Tuesday, August 12, 2014
Planning and Economic Development Board
155 Village Street
Medway, MA 02053

Medway Gardens Site Plan – Public Briefing Continuation:

Public Hearing: Tri Valley Commons Site Plan:

**Re: 38 Summer Street (Route 126)
Medway Gardens Minor Site Plan Review
Medway, Massachusetts**

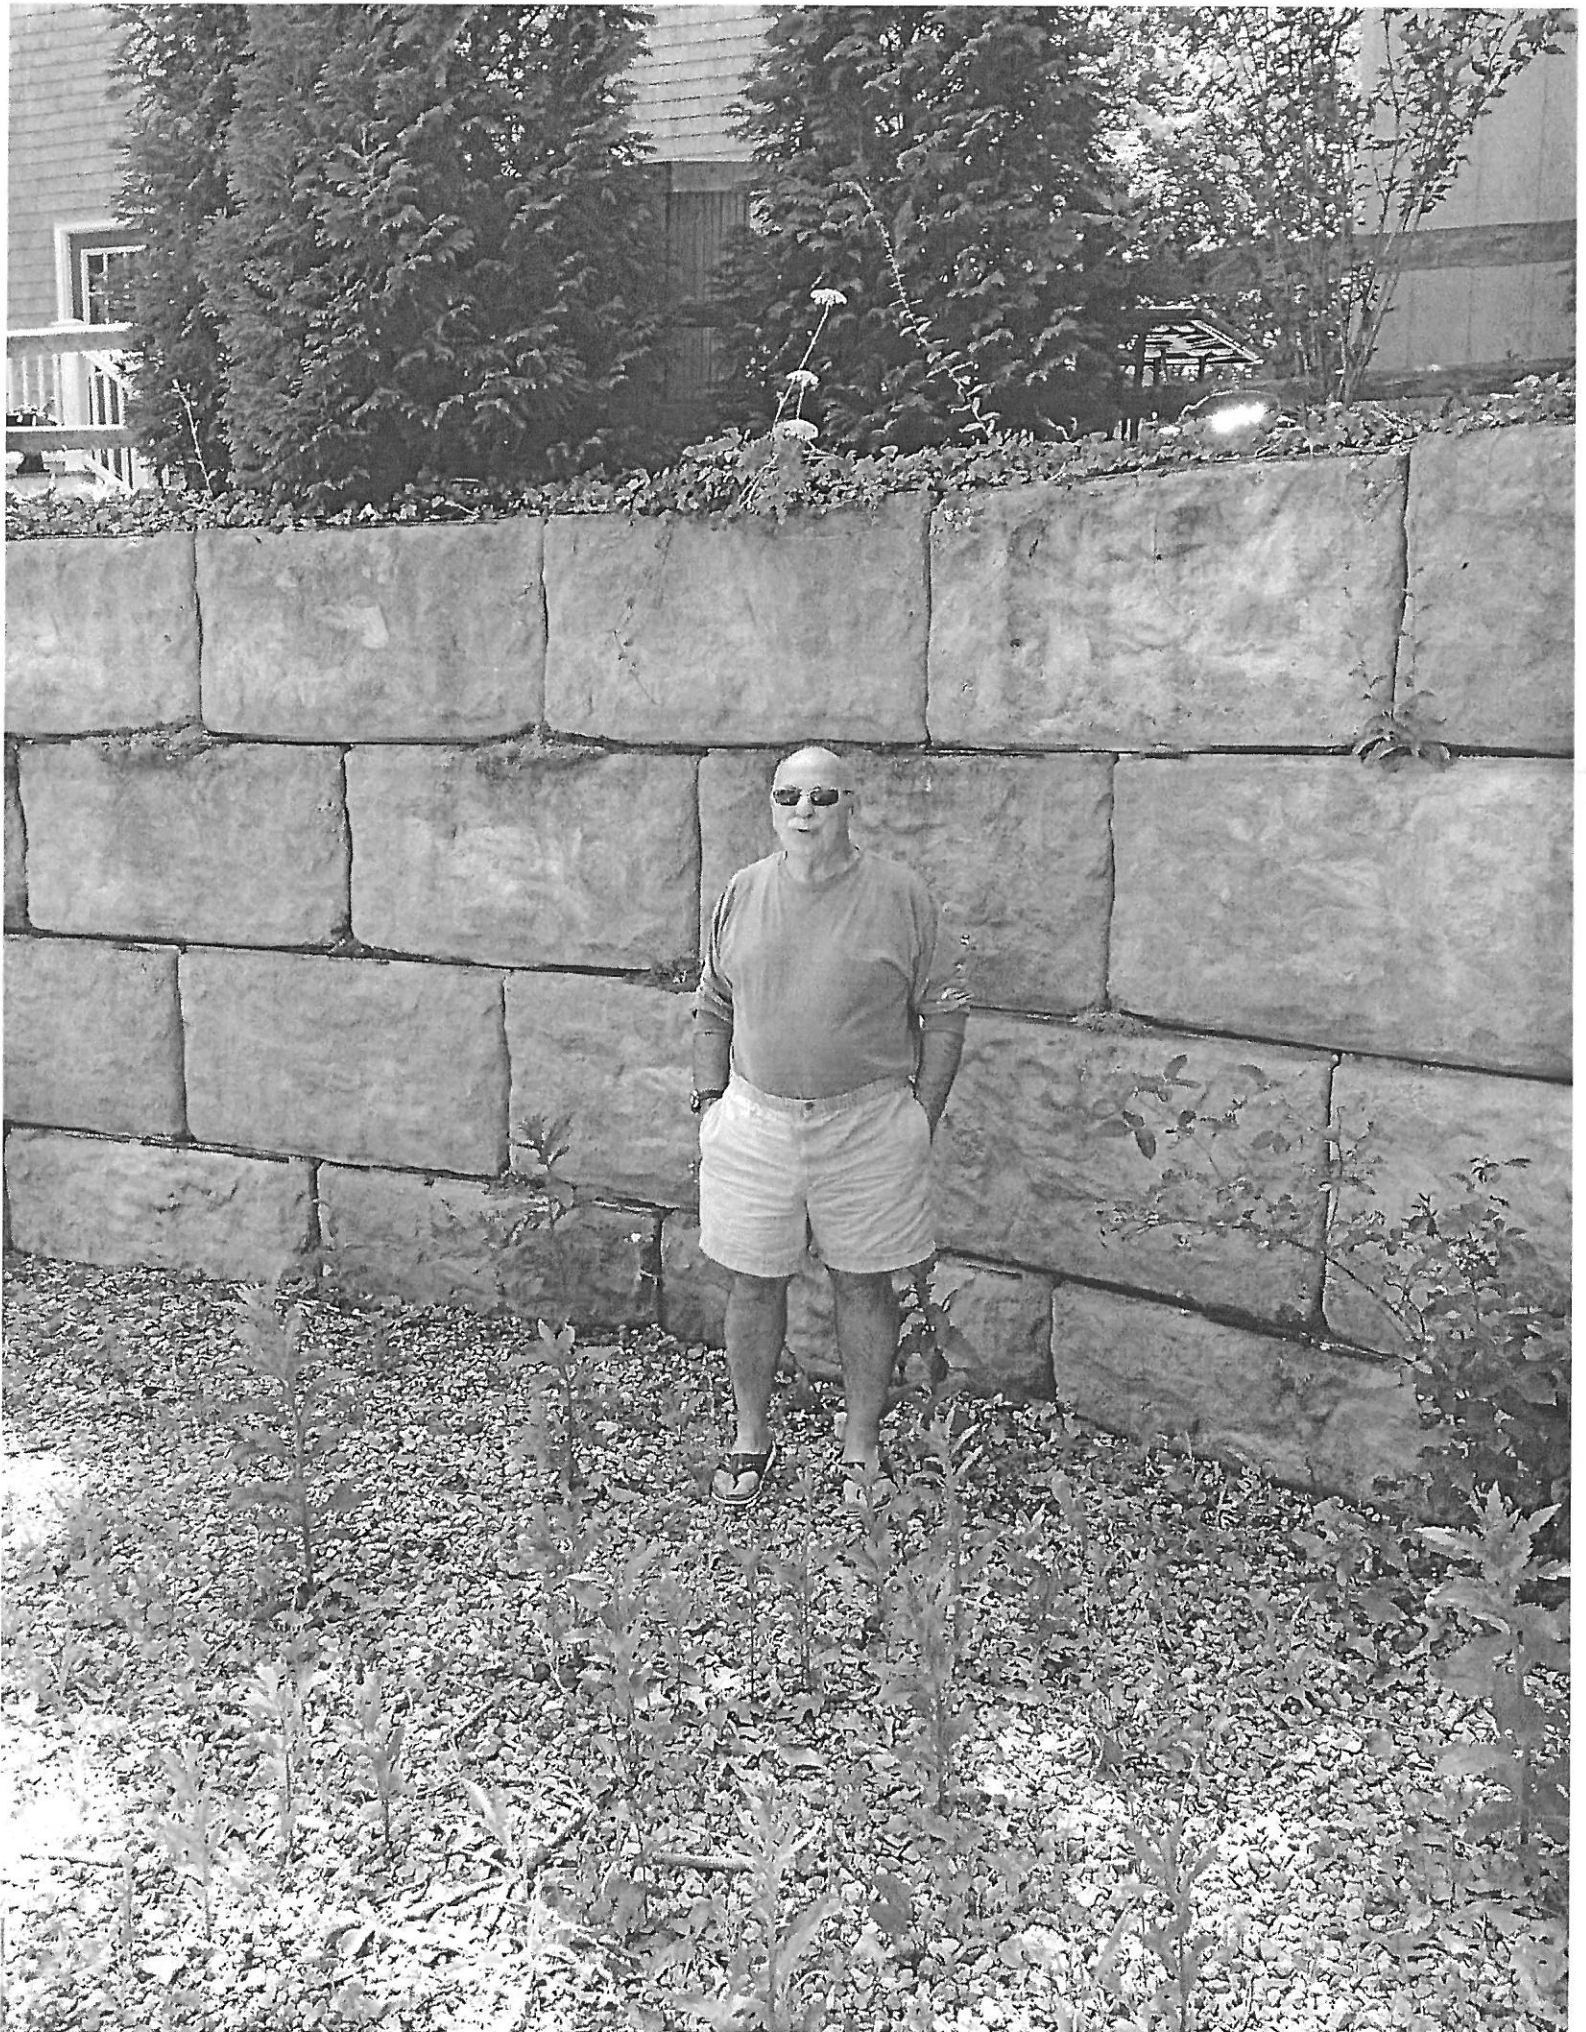
The Medway Police Department would recommend stop signs along with painted lines at the following locations.

1. The entrance from behind Papa Ginos.
2. The exit from the access road onto Main Street
3. The exit between building A and F.

We are also concerned with the lack of crosswalks allowing access to buildings with in the complex. It would be our recommendation that the Medway Planning board request a proposal showing a commitment to improving walkability and pedestrian safety. The plan should include crosswalks from the Gould's Plaza, a proper crosswalk across the entrance on Main Street along with a safe sidewalk into the plaza from Main Street and a crosswalk design connecting each building.
